## **Shelby County Landfill Turn Lanes and Access Road**

### **ADDENDUM NO. 2**

Date: November 7, 2023

REFERENCE PROJECT NO	FISCAL YEAR	SHEET NO
22-0210	2023	2-A

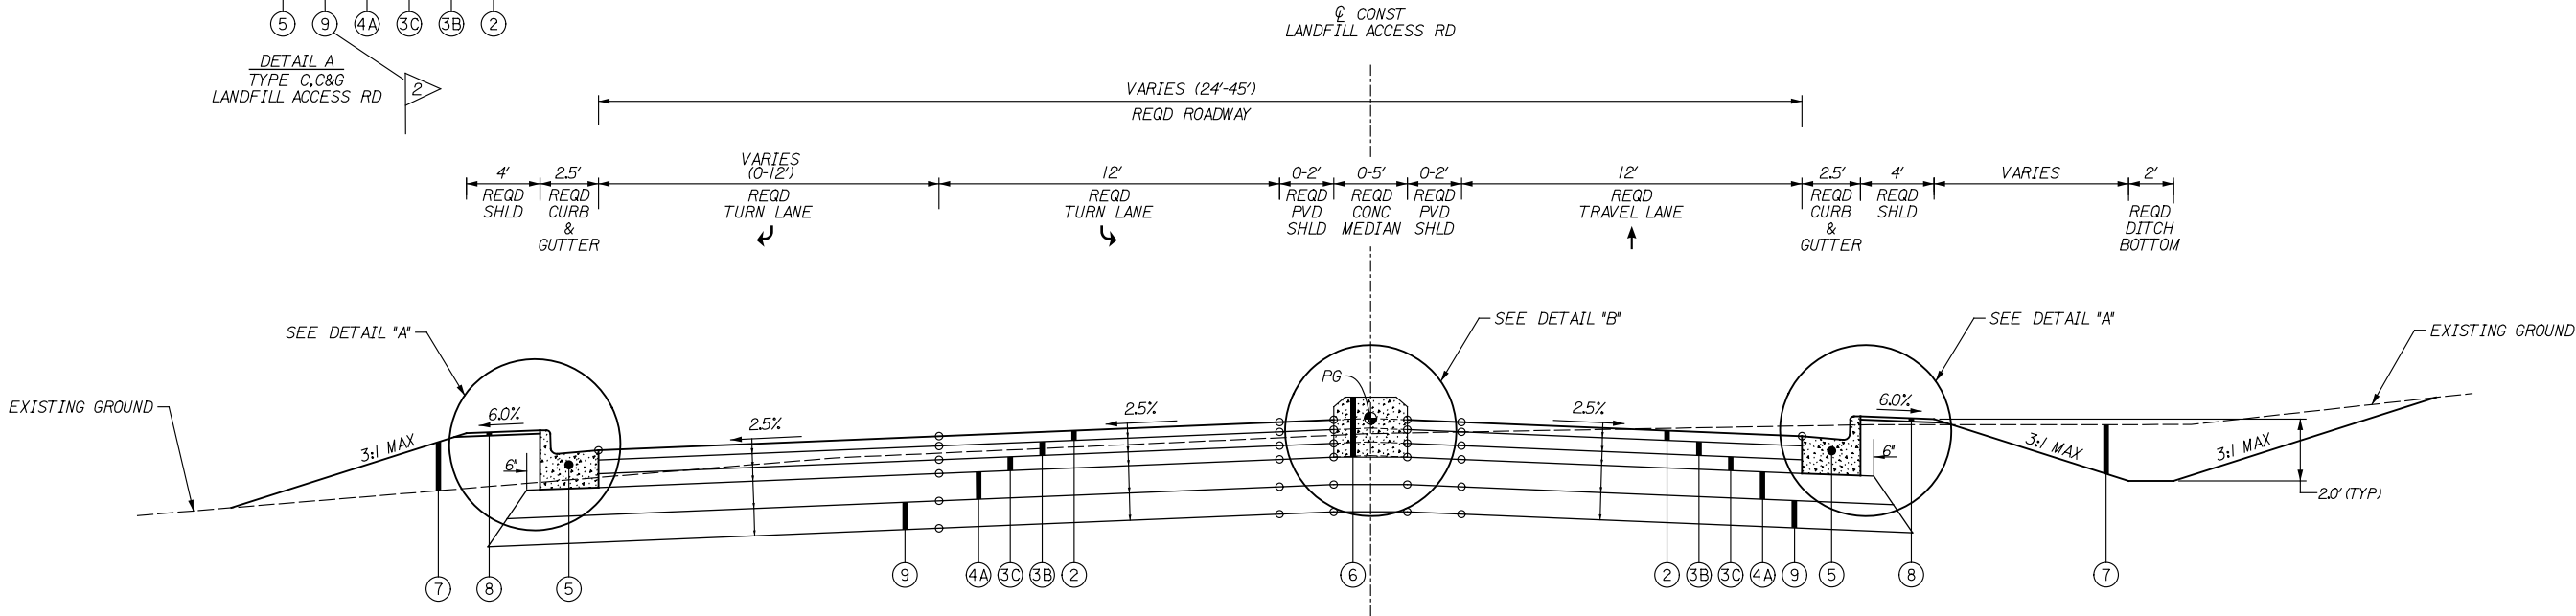
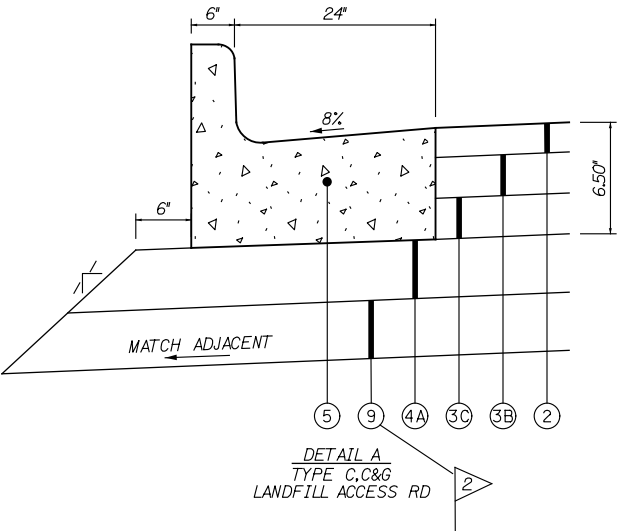
11-7-2023 - REVISED NUMBER FOR  
ROADBED PROCESSING TO "9". (JSH)
